## Product Update Notification

Product(s) affected:           MAC Panel part number **561313**

Date of issue:                    21<sup>st</sup> November 2023

New part number:                **564313**

564313 (new module)

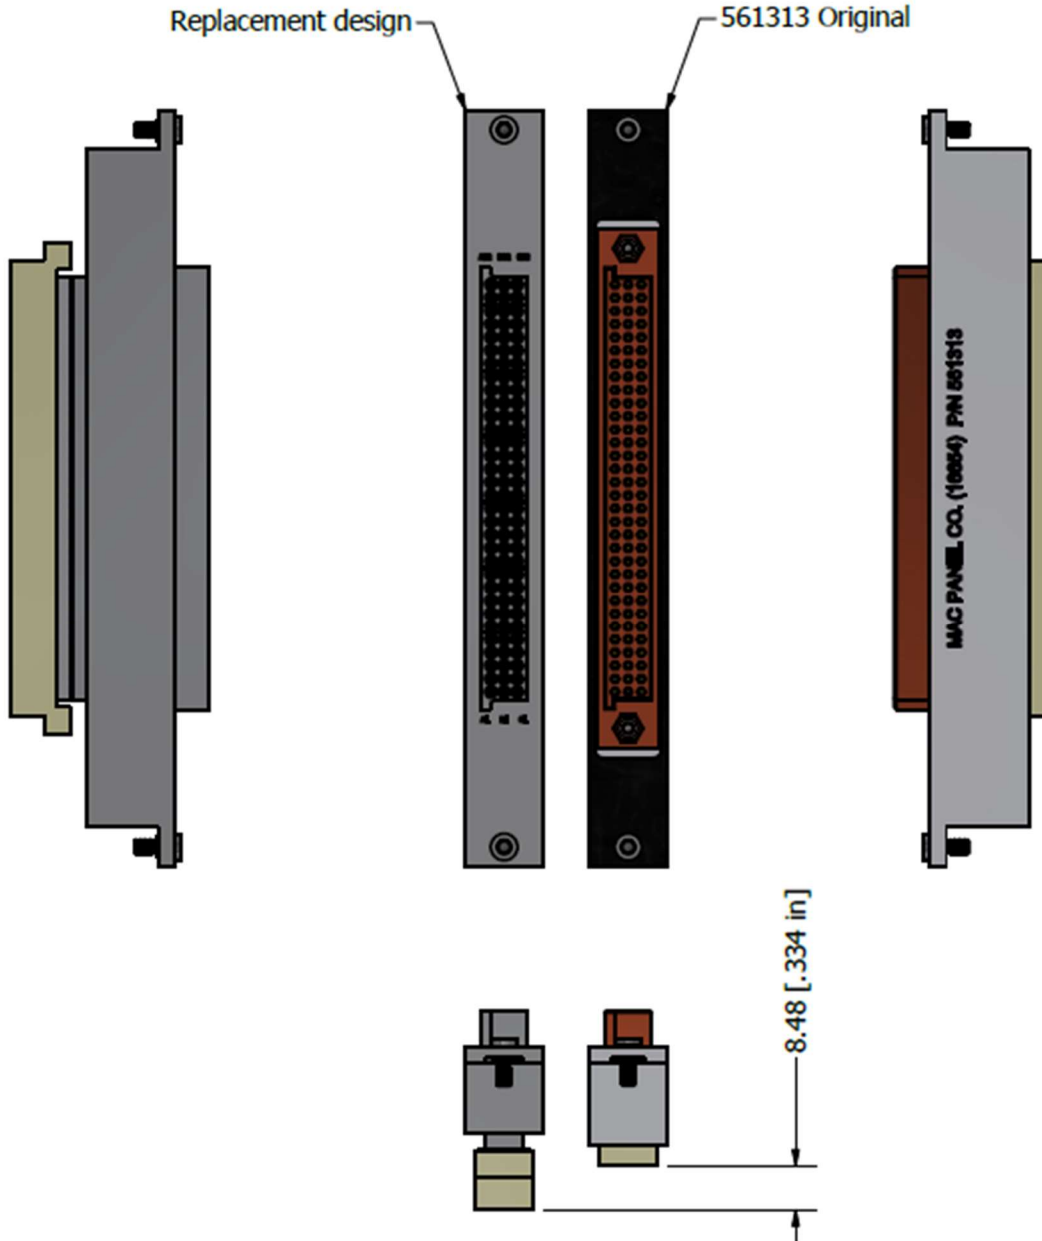
Reason:                            Originally specified 96 position connector no longer available

- Yes, the appearance of connector is different. Connector color changes from dark brown to cream. The rear side protrudes slightly more (see below for details)

- No
  - The above statement applies to the mating side of the connector. It is completely compatible with all ITA modules that currently mate with 561313.
